Technical Service Information

FORD AXOD / AXODE NEW STEEL FORWARD CLUTCH PISTON

95-14 Page 1 of 1

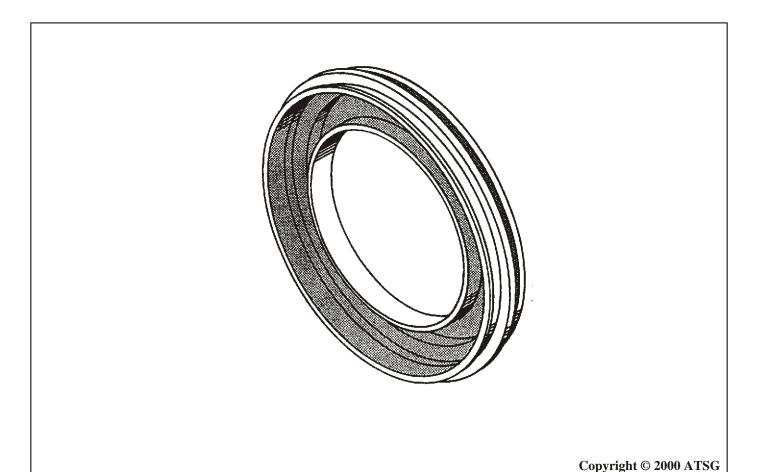
CHANGE: The forward clutch piston material has changed to steel, instead of the previous aluminum

piston.

REASON: To eliminate cracks from occuring in the seal groove, and greatly improved durability.

Forward Clutch Piston now manufactured out of steel.

Can be use on all previous models of the AXOD, AXOD-E and AX4S.

Forward Clutch Piston (all except SHO)	F4DZ-7A262-A
Forward Clutch Piston (3.2L SHO only)	F4DZ-7A262-B
